PLANNING BOARD

Tuesday, October 10, 2023 at 4:30 PM
Room 24 (Basement Level of City Hall)
and Zoom

To: Chair Mazer & Members of the Planning Board
From: Nell Donaldson, Director of Special Projects
Date: October 6, 2023
Re: Draft Text Amendments to the Land Use Code Under LD 2003
Meeting Date: October 10, 2023

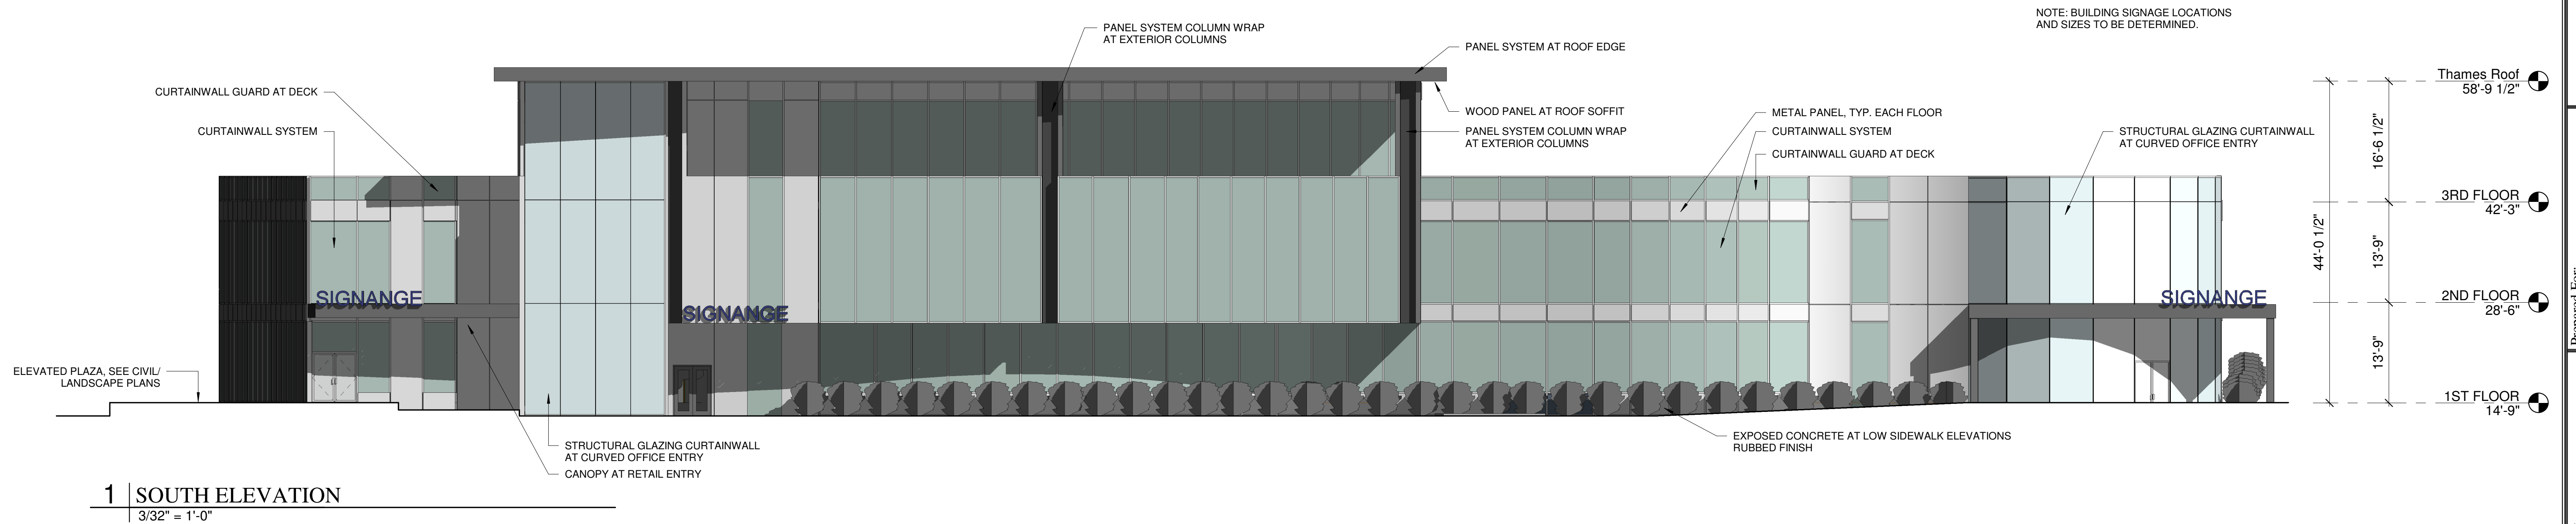
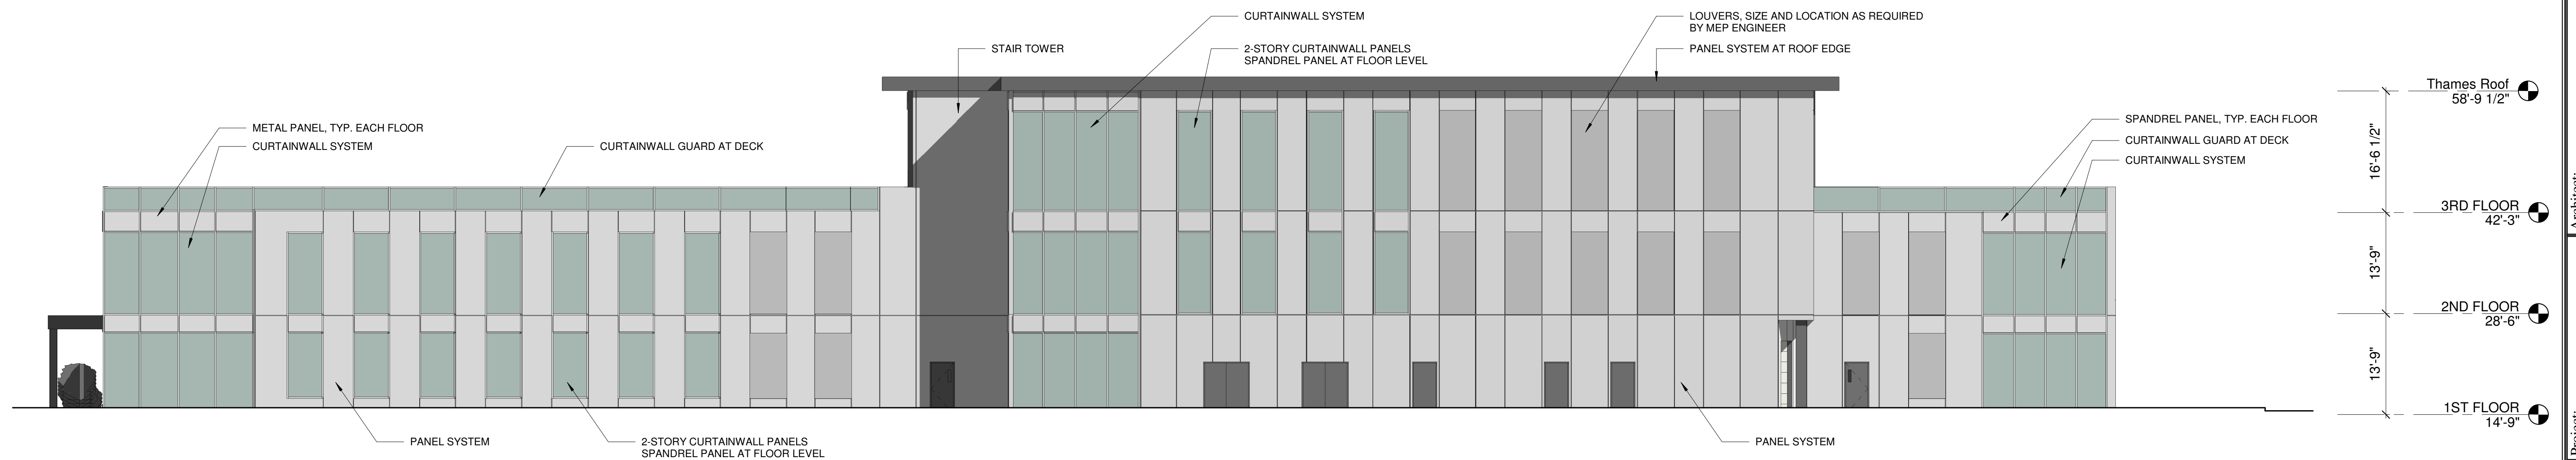
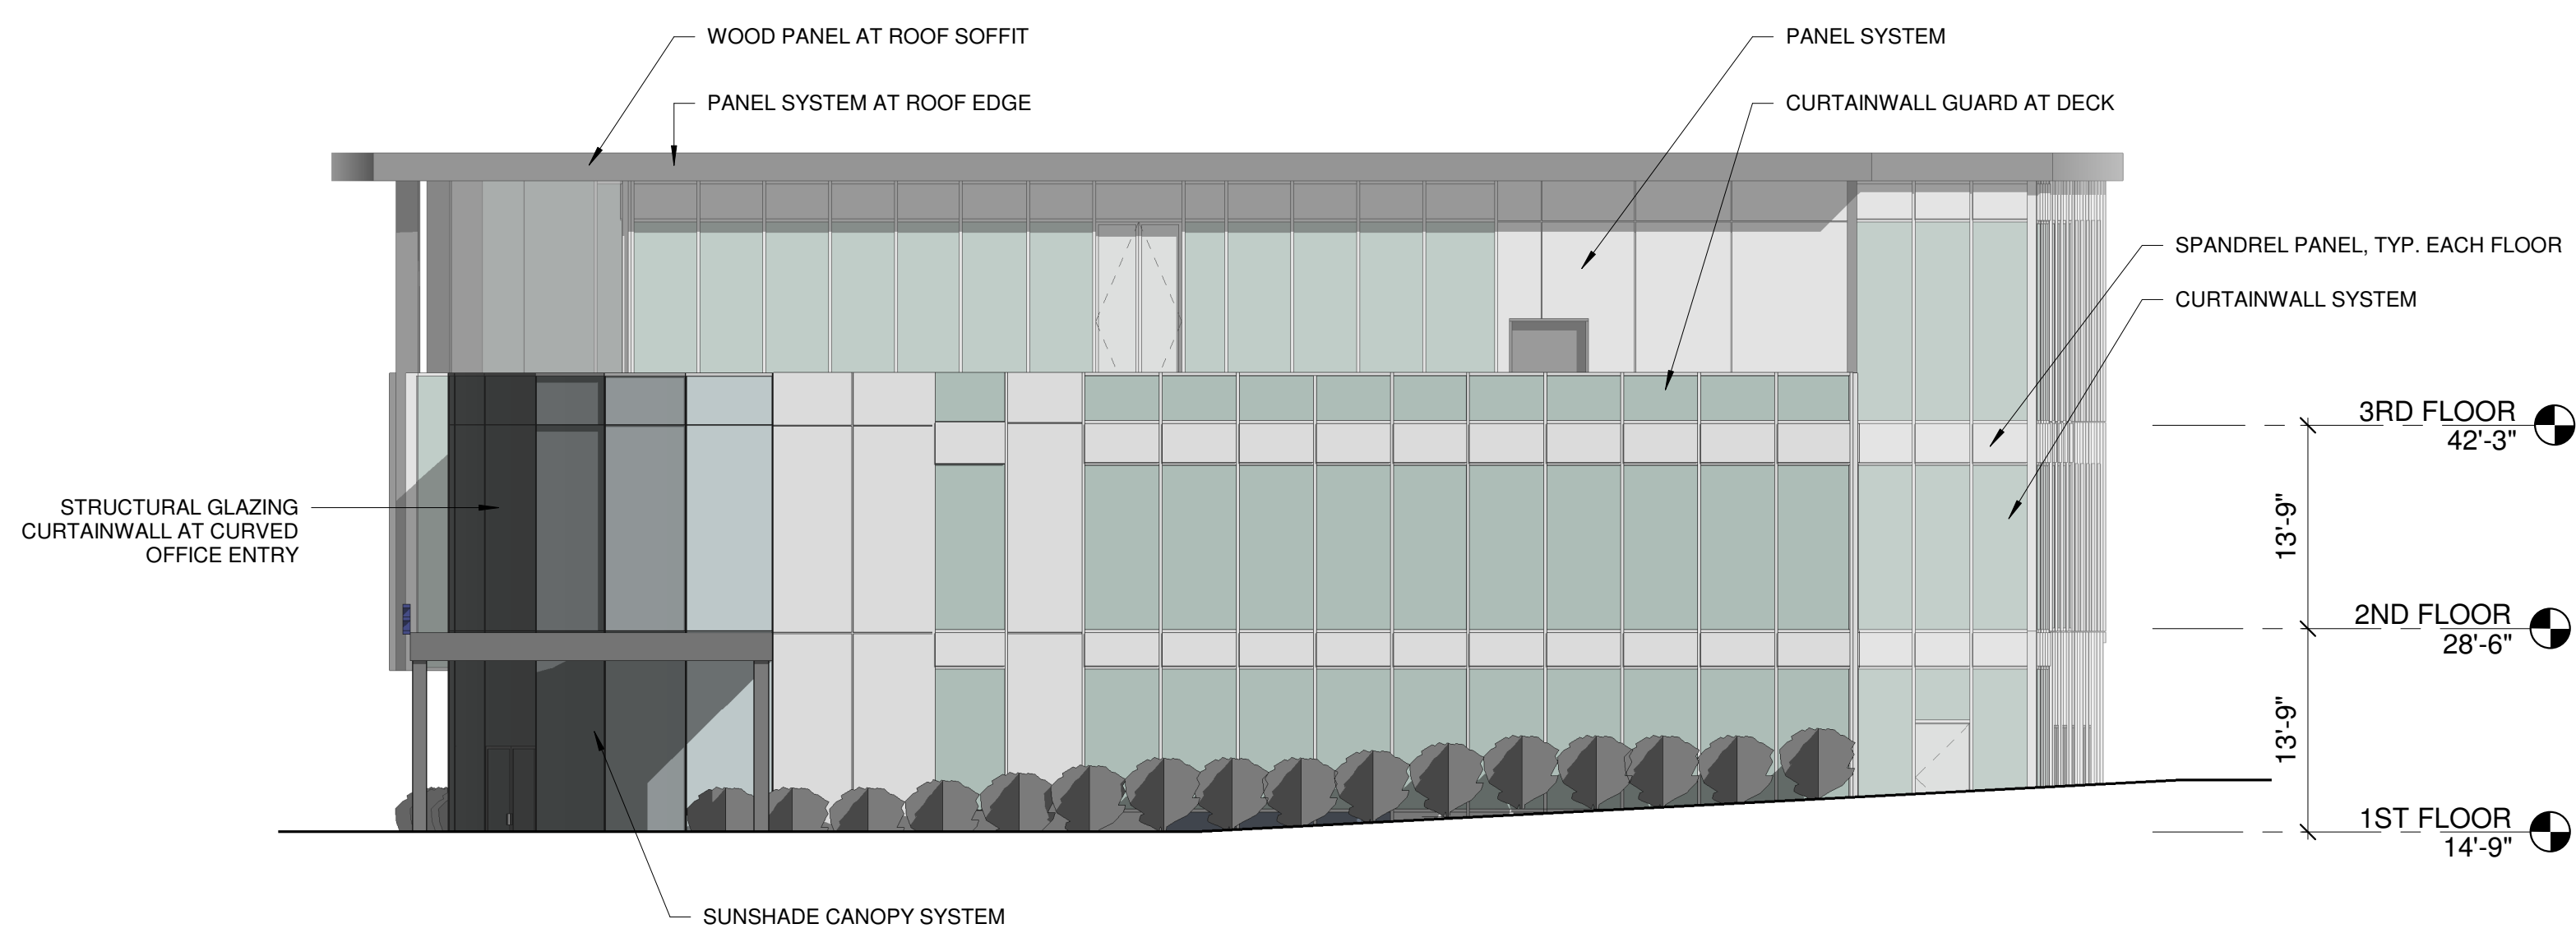
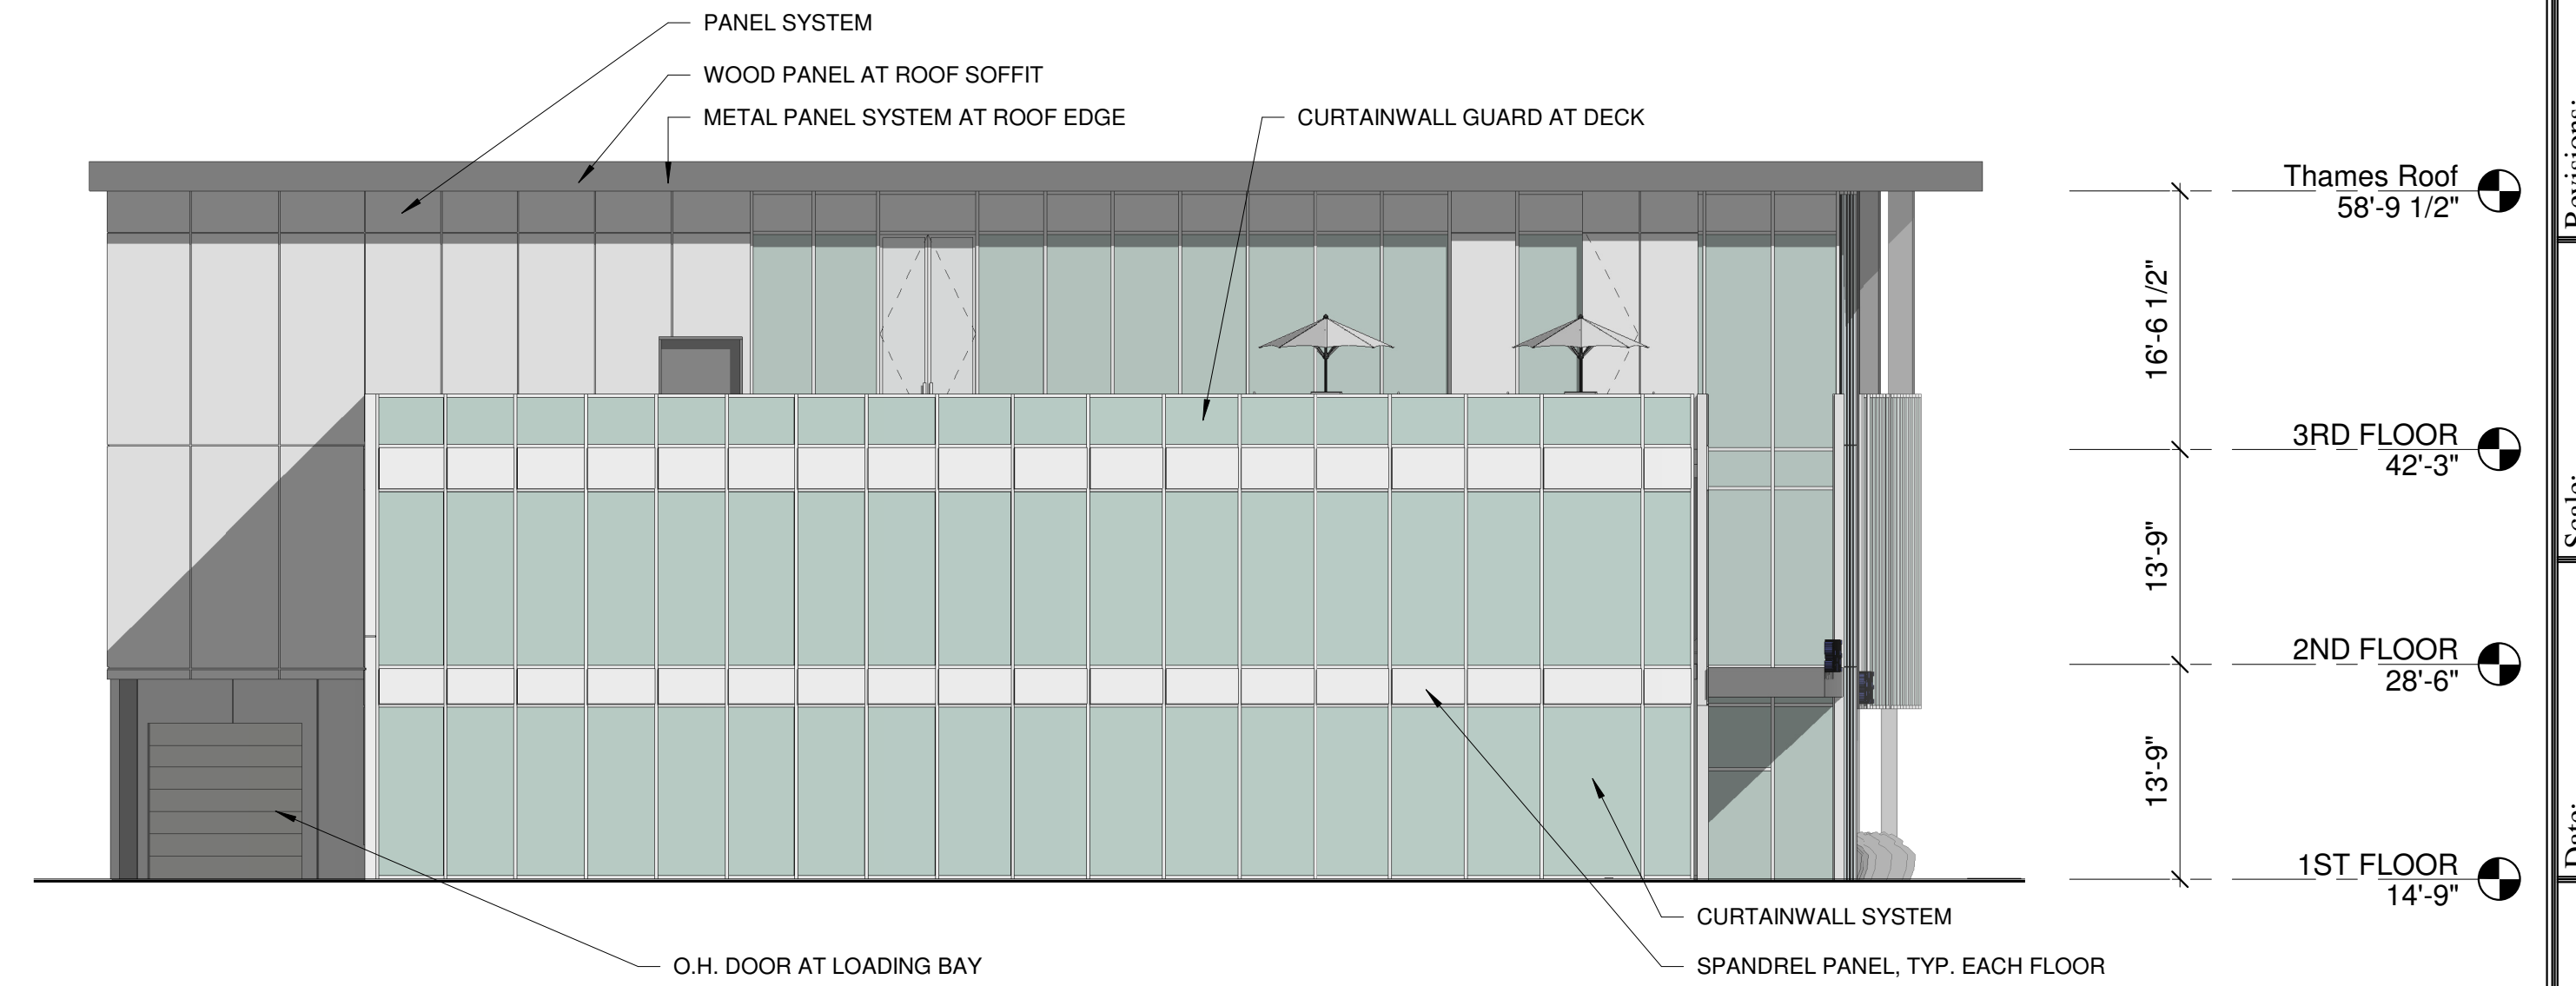
- 3. Zoning Analysis Table notes the required maximum height is 65 ft. Looking at the B-6 Zone Building Height Overlay Map, the proposed site is in the 45 ft. maximum height area. The elevations (A2.01) need to show the height from the average grade to the roof beam and also need to show how average grade is determined.*

3. Zoning Analysis Table notes the required maximum height is 65 ft. Looking at the B-6 Zone Building Height Overlay Map, the proposed site is in the 45 ft. maximum height area. The elevations (A2.01) need to show the height from the average grade to the roof beam and also need to show how average grade is determined.

- Zoning Analysis Table notes the required maximum height is 65 ft. Looking at the B-6 Zone Building Height Overlay Map, the proposed site is in the 45 ft. maximum height area. The elevations (A2.01) need to show the height from the average grade to the roof beam and also need to show how average grade is determined.
